**LTR-NRC-15-33 NP-Attachment**

**WCAP-17721-P NRC Set 2, Safety and Code Review Branch –  
RAI 2.32 Response Supplement (Non-Proprietary)**

## Background

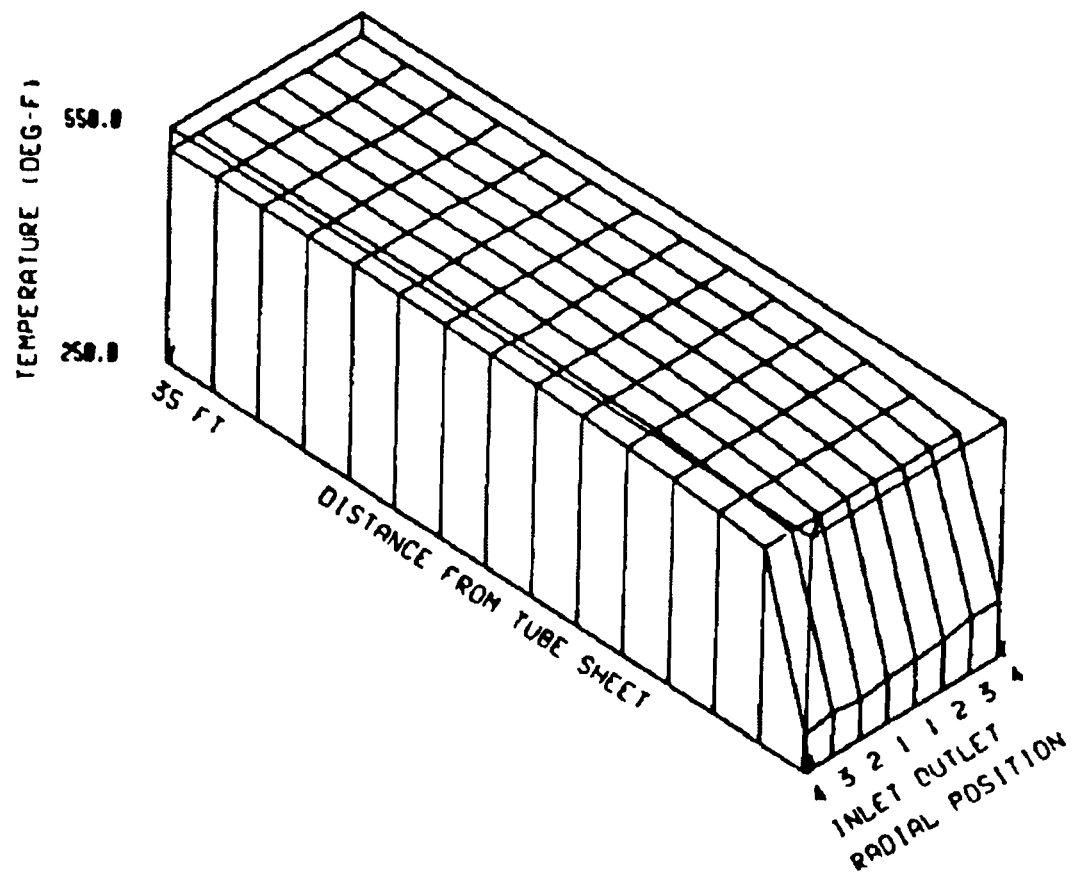
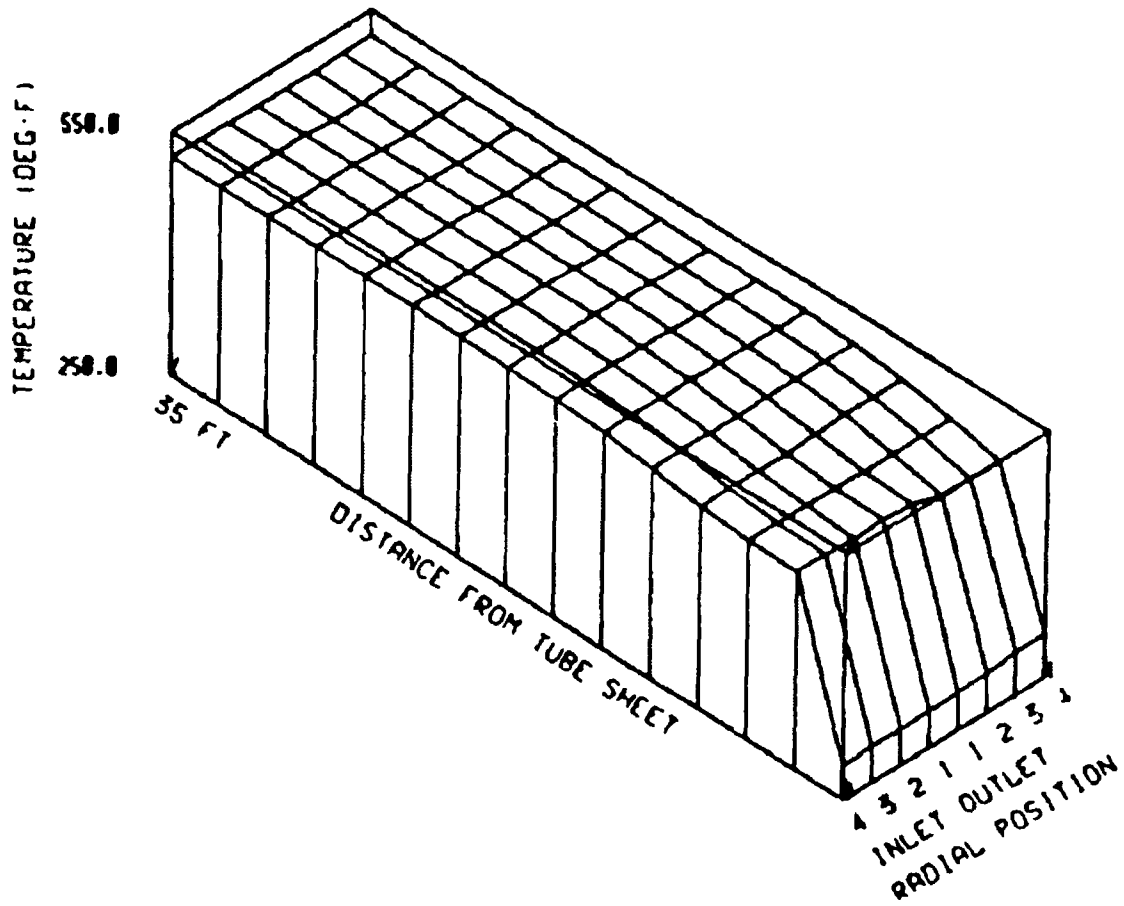
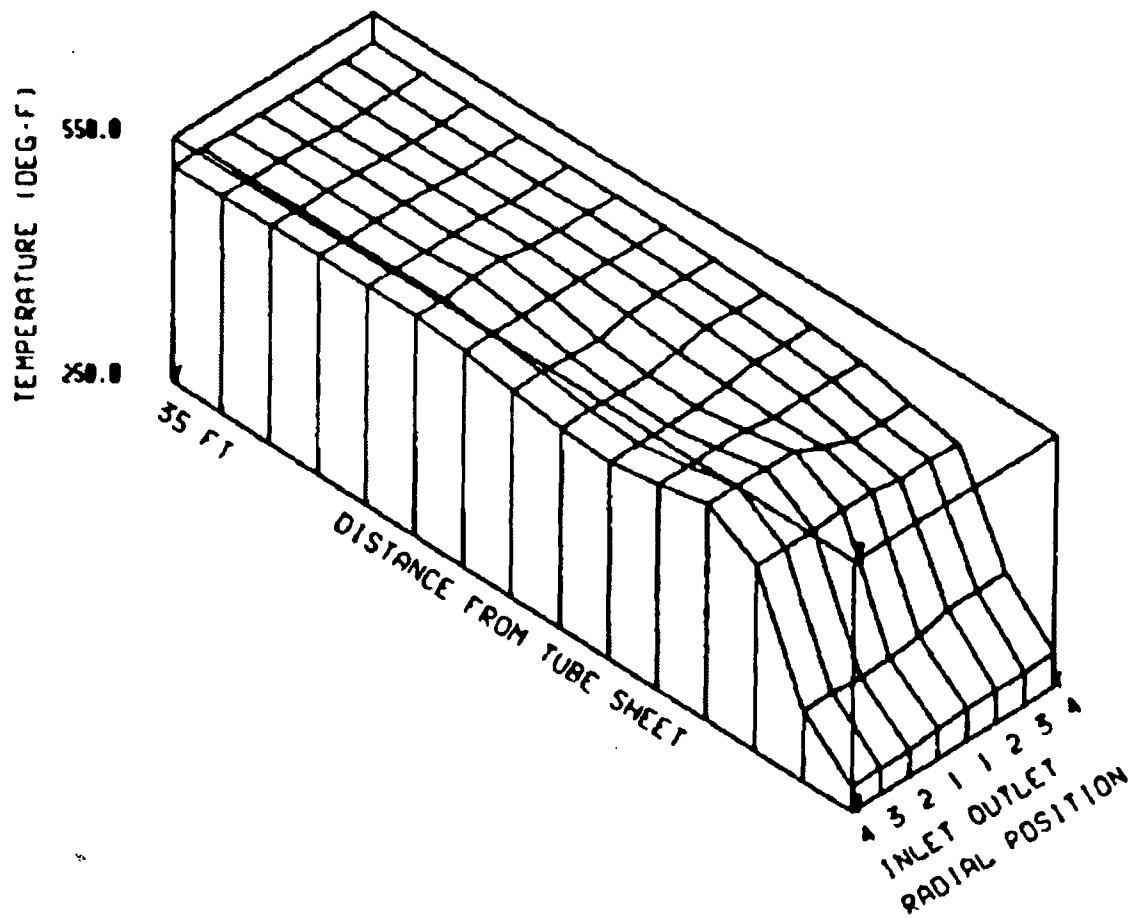
Request for Additional Information (RAI) 2.32<sup>1</sup> requested Westinghouse to generate plots of integrated secondary side energy release for the FLECHT SEASET steam generator (SG) test case simulations presented in WCAP-17721-P Section 3.2. The RAI also requested that Westinghouse provide a discussion which demonstrates that WCOBRA/TRAC (WCT) provides an adequate prediction of the FLECHT SEASET data. The response to the RAI is documented in Westinghouse letter LTR-NRC-15-20<sup>2</sup> and provided the requested plots. The response indicated that 3 of the 7 FLECHT SEASET simulations calculated secondary to primary heat transfer rates that [ ]<sup>a,c</sup> than the test data (R21806, R22314, and R22503). Test data was unavailable for a large portion of R21909, and code calculated secondary to primary heat transfer was [ ]<sup>a,c</sup> for 3 tests (R22701, R22920, and R23402). The response to RAI 2.32 indicated that the SG heat transfer data from the test was only an estimate, and it was based on the primary side energy balance. Plots showing calculated and measured secondary side temperature vs. elevation were referred to, and largely the WCT simulations calculated [ ]<sup>a,c</sup>, even for R22701, R22920, and R23402. During the April 8-9 Nuclear Regulatory Commission (NRC) audit, the NRC pointed out that the WCT [ ]<sup>a,c</sup> than measured and that the measured [ ]

[ ]<sup>a,c</sup>. There was also an ongoing discussion relative to the 'spike' in secondary to primary heat transfer shown early in time for some of the tests.

Westinghouse's argument that the WCT FLECHT SEASET SG simulations provided conservative results relative to secondary to primary heat transfer was primarily based on the [ ]<sup>a,c</sup>. WCAP-9724 (NUREG/CR-1534)<sup>3</sup> contains isometric plots which show radial secondary side temperatures vs elevation above the tube sheet for R22701. Figure 5-46 through Figure 5-48 (reproduced below) indicate that there is [ ]<sup>a,c</sup> at any given time and elevation. The lack of [ ]<sup>a,c</sup> can be demonstrated for R22920 and R23402 as well with
